Downtown

Road Safety Audit

June 7, 2018

AECOM

Figure 6 Heavy Truck Route

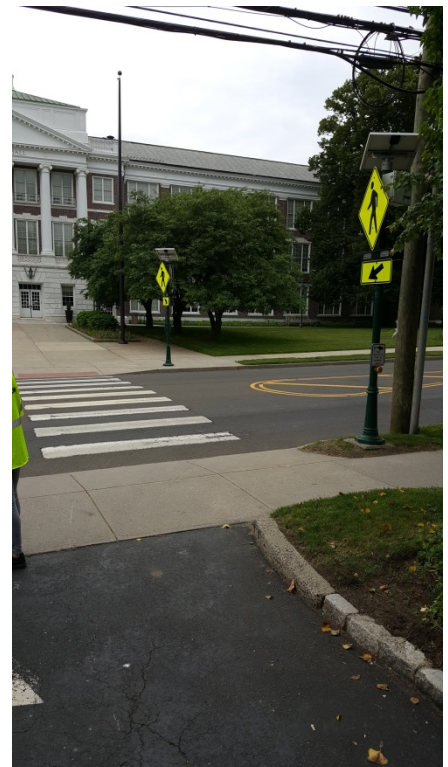
- Sight distance is restricted coming uphill on Sound View Drive by a stockade fence and vegetation (apparently on private property).
- This is heavily used as a truck route between I-95 and Route 1 (Figure 6).

Figure 14. Short Term Recommendations

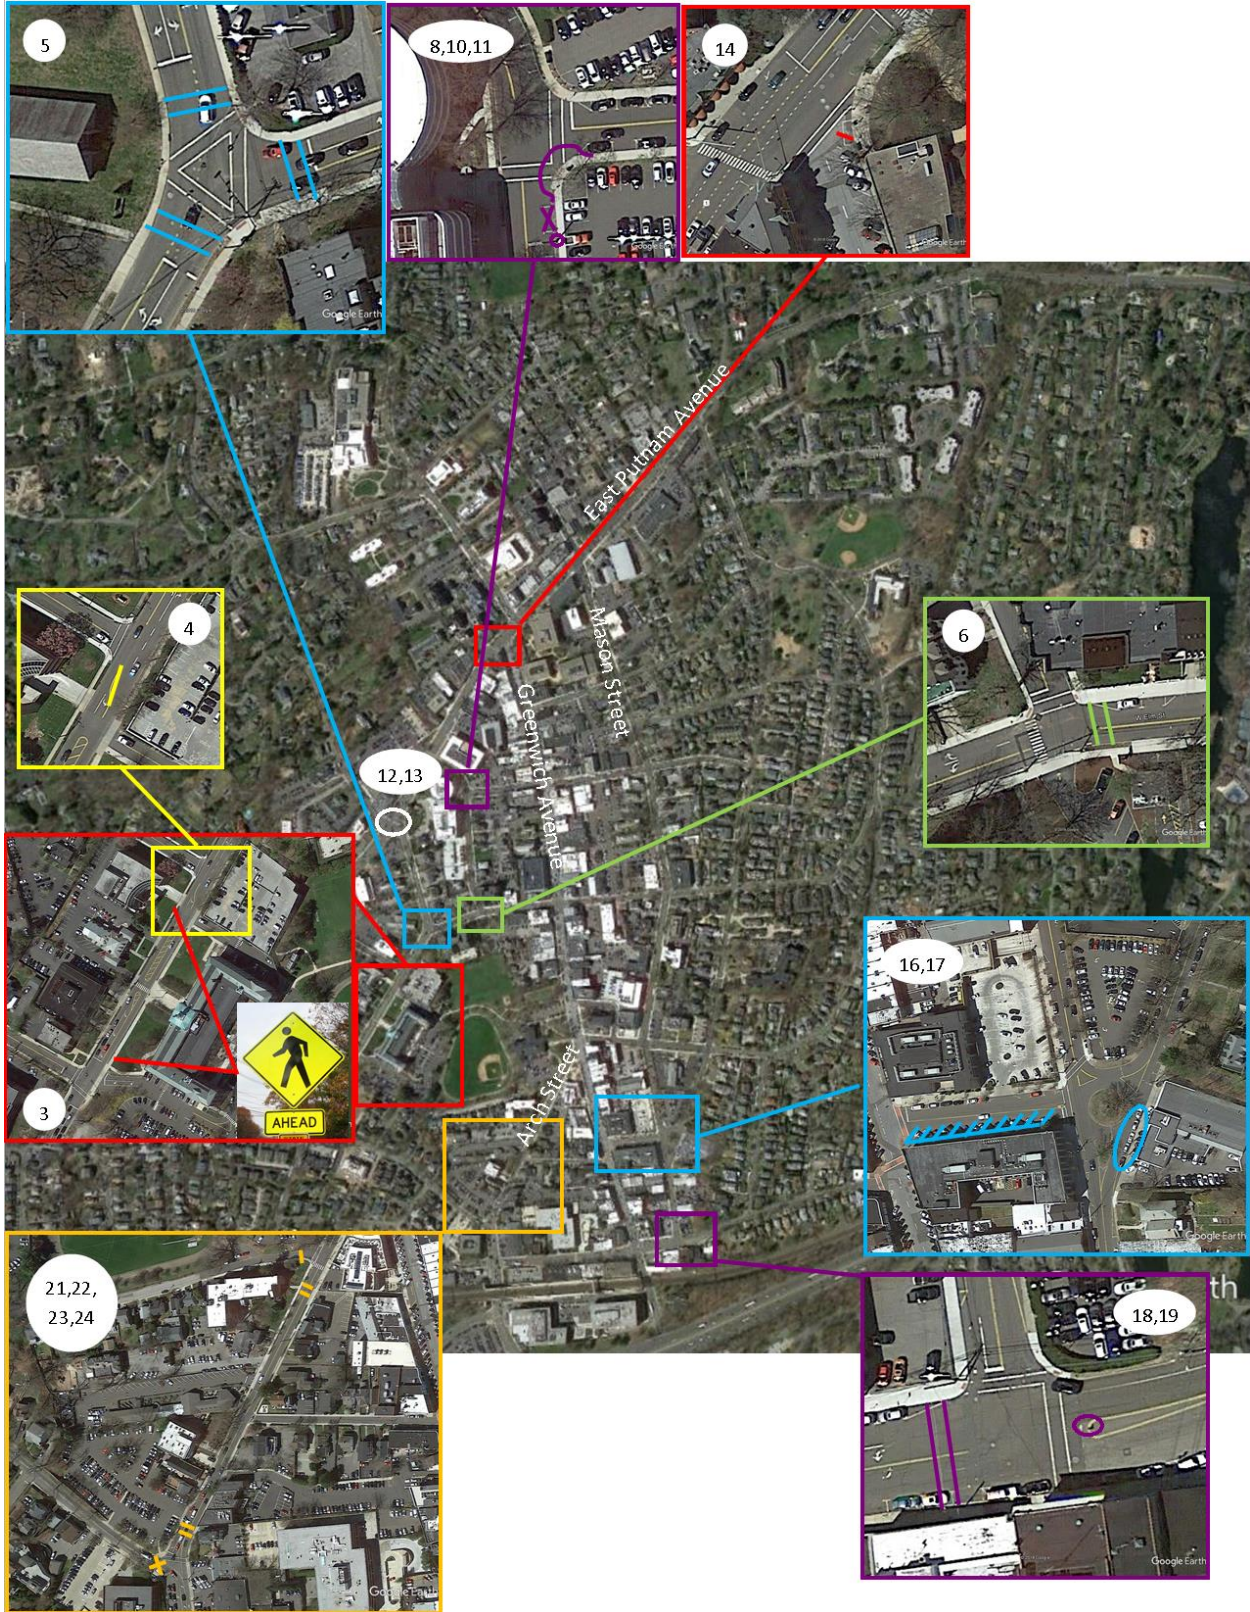
1. Revise/change current crosswalk policy to adopt one standard crosswalk type, e.g. bar-type.
2. Create and enforce a tree ordinance
3. Install advance crosswalk signs on Field Point Road at Town Hall Crosswalk.

4. Lengthen the left turn lane for traffic on Field Point Road entering the Town Hall driveway by straightening the taper on the double yellow line.
5. Realign crosswalk on all four legs of Field Point Road/West Elm Street to be perpendicular with the roadway.

6. Relocate crosswalk to the east side of the intersection away from the existing driveway at West Elm Street/Benedict Place.
7. Raise low crosswalk signs to 7' at West Elm Street, Lewis Street, Sound View Drive, Arch Street, and Benedict Place.

8. Consider adding a flush bumpout on southeast corner of Lewis Street/Benedict Place.
9. Maintain overgrown vegetation on Benedict Place, and Dearfield Drive.

10. Move Parking sign from Utility Pole to proper post mounting at Lewis Street/Benedict Place.
11. Eliminate one parking space on Benedict Place south of Lewis Street.

12. Evaluate right turn traffic volumes, sightlines, pedestrian activity, crashes, etc. to see if prohibiting right turns on red is warranted on West Putnam Avenue (US-1)/Field Point Road/Dearfield Drive.

13. Evaluate pedestrian crossing times at West Putnam Avenue (US-1)/Field Point Road/Dearfield Drive.
14. Convert parallel handicap space on east side of Greenwich Avenue near West Putnam to an angle space.

15. Add wayfinding signs throughout the downtown area.
16. Consider converting back-out angle spaces on south side to head out spaces as a pilot program on Fawcett Place; promote education program and monitor results. Consider a "try-it" day for residents.

17. Work with the car dealer at the Milbank Avenue Roundabout to have vehicles removed from the public walkway.
18. Change center pedestrian bollard sign to "Yield to Pedestrian" at Mason Street/Bruce Park Avenue.

19. Consider relocating the crosswalk or adding a crosswalk on the west side of the intersection of Mason Street/Bruce Park Avenue. Remove on-street parking spaces, as necessary.

20. Repair the broken Pedestrian Flashing Sign and in-pavement warning devices at the Railroad Avenue mid-block crosswalk.
21. Move crosswalks away from the intersection and make them perpendicular to the crossing roadway at Arch Street and Sound View Drive.

22. Eliminate crosswalk on Sound View Drive at Sound View Drive/Arch Street.
23. Relocate crosswalk further south on Arch Street and provide advance crosswalk signage and "Do Not Block" crosswalk sign on northbound approach at Arch Street/Bolling Place.

24. Relocate Stop sign and install stop Bar on Bolling Place approaching Arch Street.
25. Develop a policy for electric charging stations.
26. As part of Greenwich Avenue streetscape design, consider removing parking meters and implementing central pay location system. This may provide opportunities for providing new pedestrian amenities such as buffer spaces, landscaping, and street furniture.

Figure 16. Long Term Recommendations

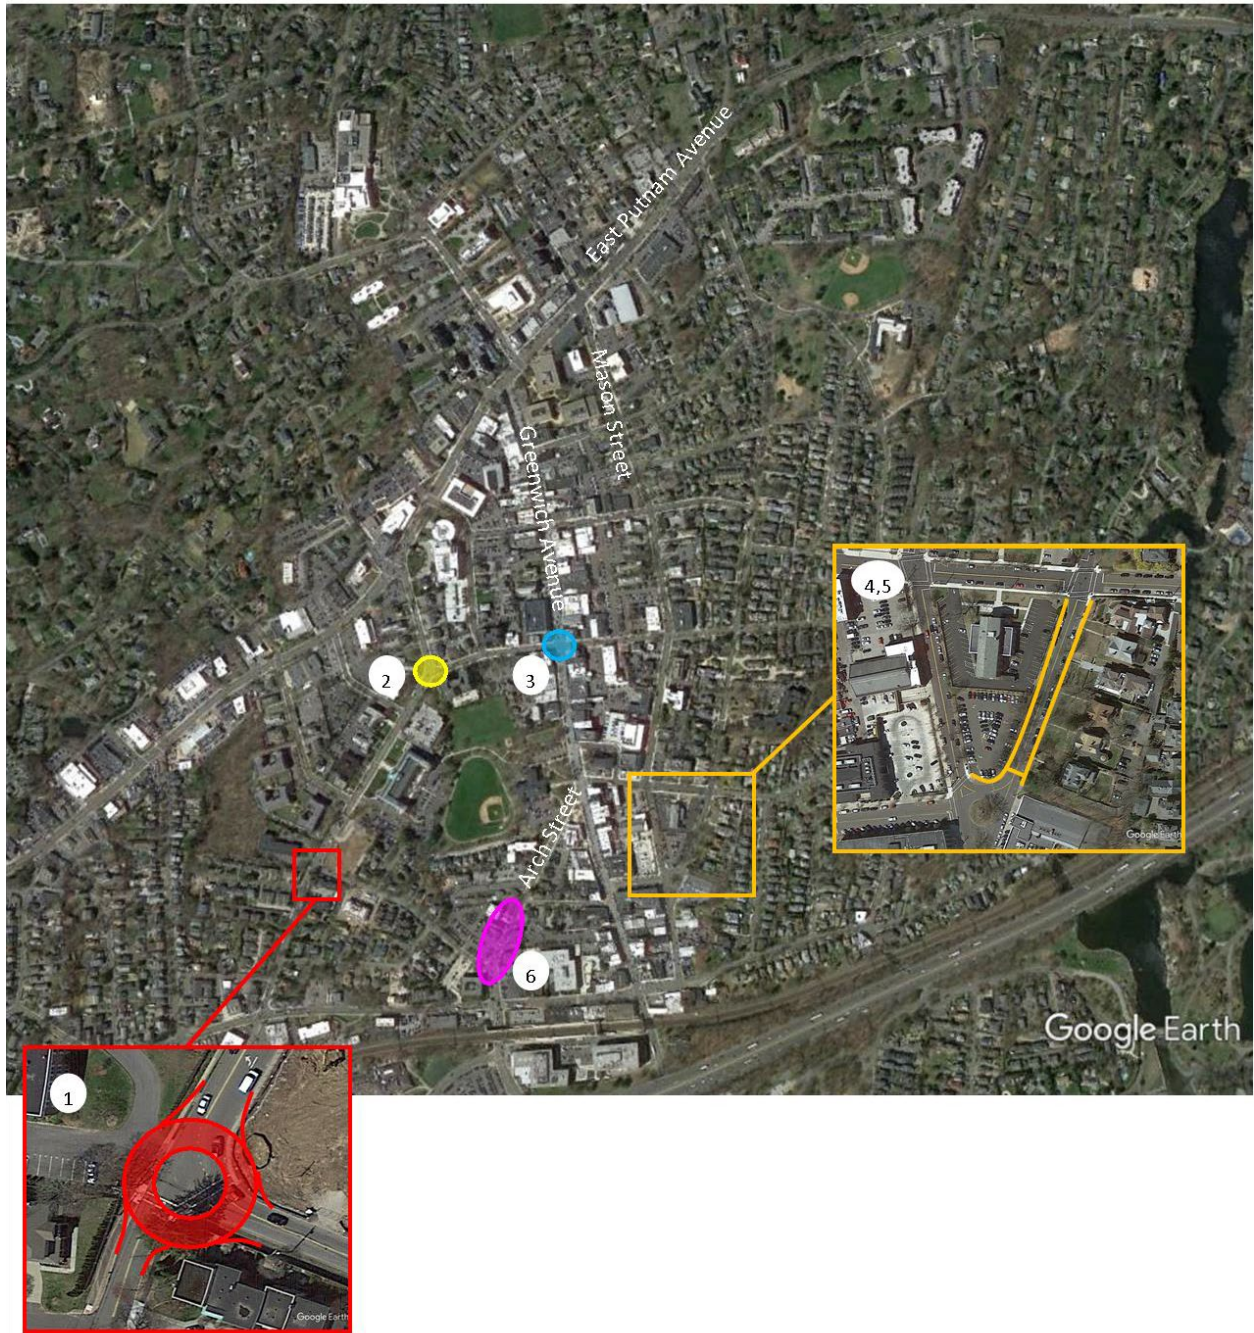
1. Evaluate installing a roundabout at Sound View Drive/Field Point Road.
2. Upgrade the traffic signal at Field Point Road/West Elm Street.
3. Conduct a study to determine if a signal is warranted at Greenwich Avenue/West Elm Street, and install the signal if it is warranted.
4. Consider adding sidewalk on the west side of Millbank Avenue with connection to Mason Street, and a pedestrian crossing to the east side of the street.
5. Upgrade the sidewalk on the east side of Milbank Avenue.
6. Evaluate options to eliminate the southbound Arch Street through movement by channelization or by making Arch Street one-way northbound.
7. Revisit all pedestrian ramps for ADA compliance, and upgrade ramps as parts of other projects, or as a targeted project over the next several years.
